From: Michael Eastham <Michael.Eastham@arun.gov.uk>
Sent: 30 April 2021 11:52
To: Planning.Responses <Planning.Responses@arun.gov.uk>
Subject: FW: Re: *EXTERNAL: RE: Felpham - FP/248/20/PL

Please upload onto Ocella the email below which is a response **from the applicant to ADC Neighbourhood Services** regarding planning application **FP/248/20/PL**.

Changing facilities:

Pipe Protector Cage

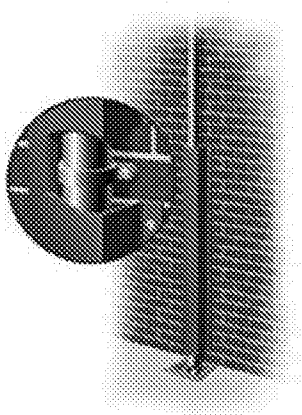
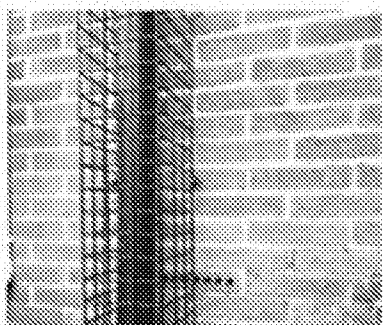
1. Downpipe lockable cages or protector:

The preference is that downpipe are protected by brick buttress rather than cages that look unsightly and would need further maintenance.

We are happy to provide the brick buttresses instead of the wire cages for drainpipe protection, and to provide Option 2 for services (heating etc). We will not be making further alterations to the changing facilities building in terms of layout.
